**Report of the Chief Planning Officer**

**CITY PLANS PANEL**

**Subject: APPLICATION 13/00288/RM – RESERVED MATTERS APPLICATION FOR 189 HOUSES, ONE BLOCK OF 9 APARTMENTS AND ONE BLOCK OF 6 APARTMENTS INCLUDING ASSOCIATED LANDSCAPING AT OPTARE, MANSTON LANE, CROSS GATES, LEEDS, LS15 8SU.**

13/00288/RM

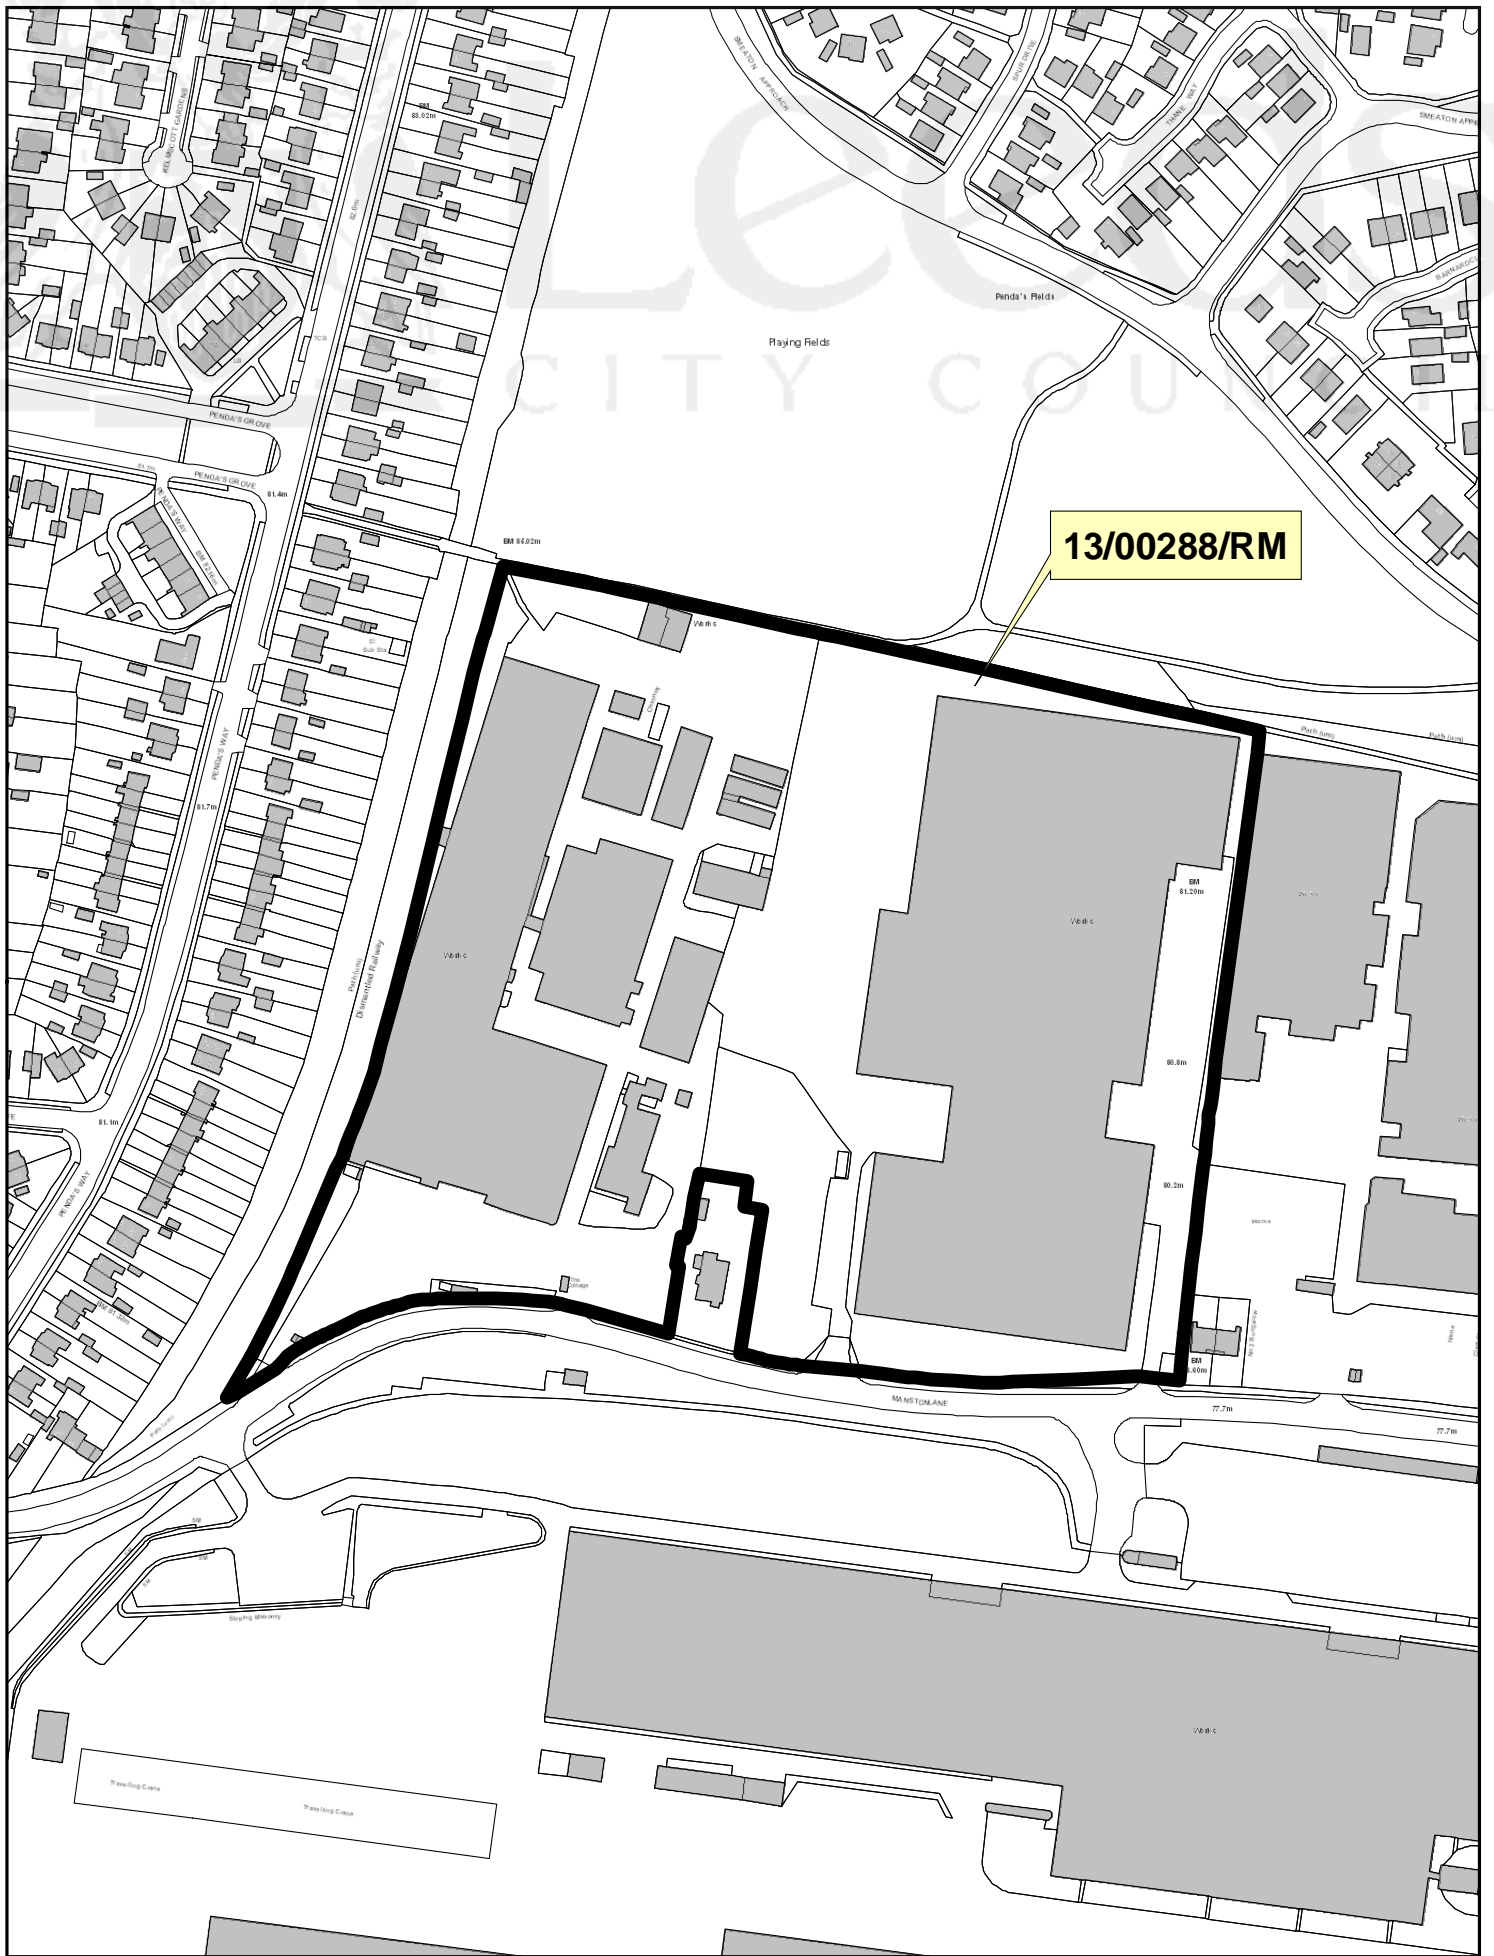
- 10.11 However, the layout does result in many houses being very close together with gaps rarely greater than 2m when guidance would normally seek to achieve 3.5m. Whereas 3.5m is not necessarily required in every instance, the prevalence of narrow gaps between houses is considered detrimental to the character of the development. The current separation distances and layout of the house types also results in a dominance of car parking along street frontages. These factors would point toward a general overdevelopment of the site and officers are seeking to negotiate improvements.

- 10.12 Guidance with Neighbourhoods for Living seeks rear garden depths of 10.5m and have an area approximately two thirds of the gross floor area of the house. Whereas this is not applied as an exact science in every instance, some of the garden depths are as short as 6m with many around 7-9m therefore officers are also seeking improvements to address these deficiencies.

- 10.13 Many of the shorter garden depths are along the western boundary that abuts a line of off-site trees. These shorter garden depths result in the tree canopies overhanging the gardens and being within close proximity to rear windows. Guidance seeks to ensure good distances to trees to reduce the threat to that tree from future residents that may seek its removal if the tree blocks light or has other adverse impacts on the property. Officers have requested the applicant examines

- 10.16 Officers have previously raised concerns about the position of a substation in the corner of the public open space and this is still proposed. Revisions will therefore be sought including enhancements to the character and attractiveness of the public open space, an additional footpath link to the playing fields to the north and enhanced tree planting along the northern boundary.

- 10.17 Whereas the general layout of properties set around a central greenspace and ordered streets is entirely appropriate, the issues highlighted above generally indicate the site overdeveloped and officers are seeking a reduction in the total number of units proposed and/or the mix to allow improvements to the separation distances, greater garden depths and reduction in car dominance.

- 10.19 Notwithstanding the above, some of the units appear to have steeply sloping roofs that results in a top heavy house type and the linking of three-storey properties into terraces often has an adverse impact on the streetscene therefore officers are discussing changes to these elements to enhance the character of the development.

10.27 Whereas the major highway issues are largely addressed there are a number of deficiencies in the site layout that still need to be addressed. These include short driveways, sightlines, narrow garages/car ports and inappropriate bin store locations. These issues are currently being addressed by the applicant and it is hoped updated drawings will be provided prior to Panel.
